**CITY OF PORTLAND, MAINE  
DEVELOPMENT REVIEW APPLICATION  
PLANNING DEPARTMENT PROCESSING FORM  
Planning Copy**

**2007-0088**  
Application I. D. Number

**Amendment to Plan - Mercy Hospital**  
Project Name/Description

**Subject:       Mercy Hospital  
                  Fore River Site Project Amendment**

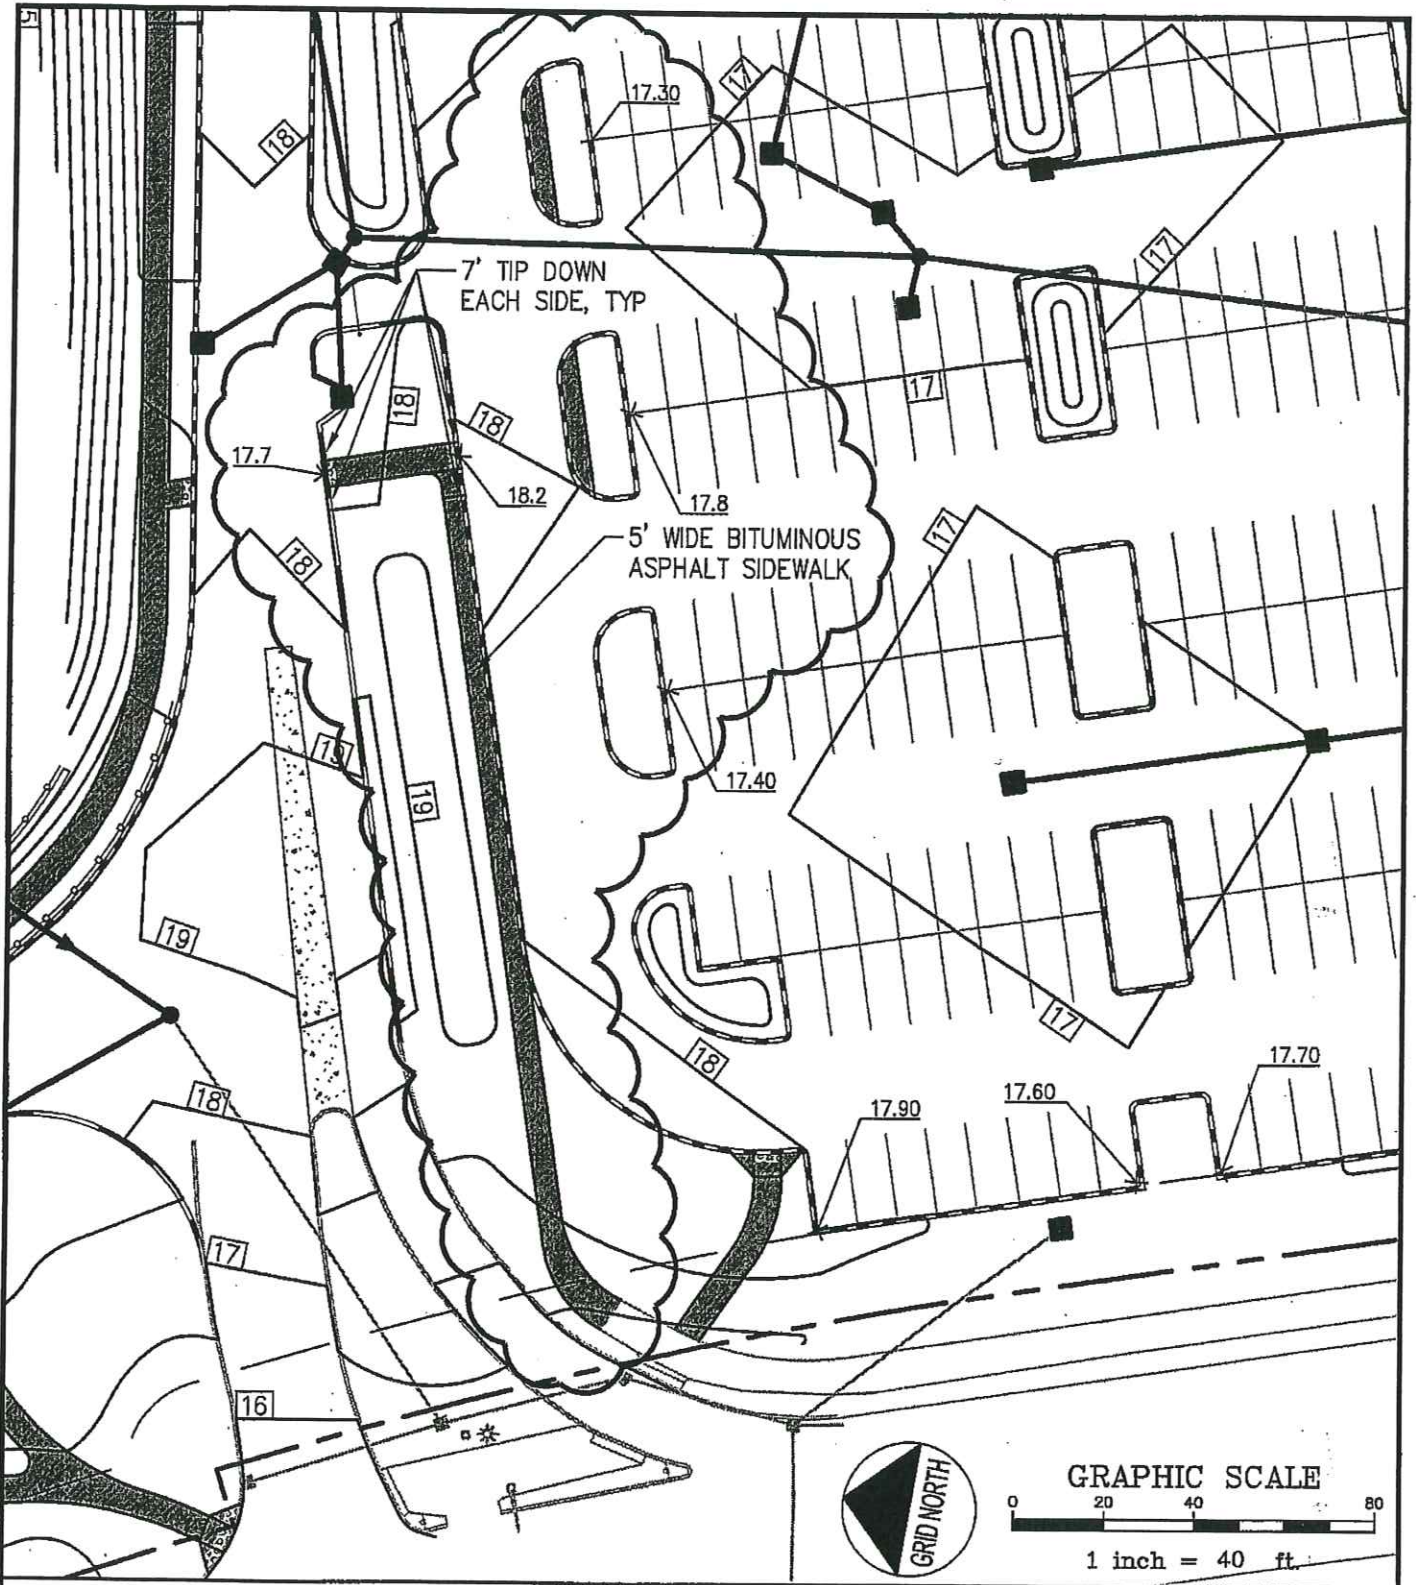
I've attached a figure depicting the sidewalk alignment we have discussed for the southerly parking area. Is this sufficient?
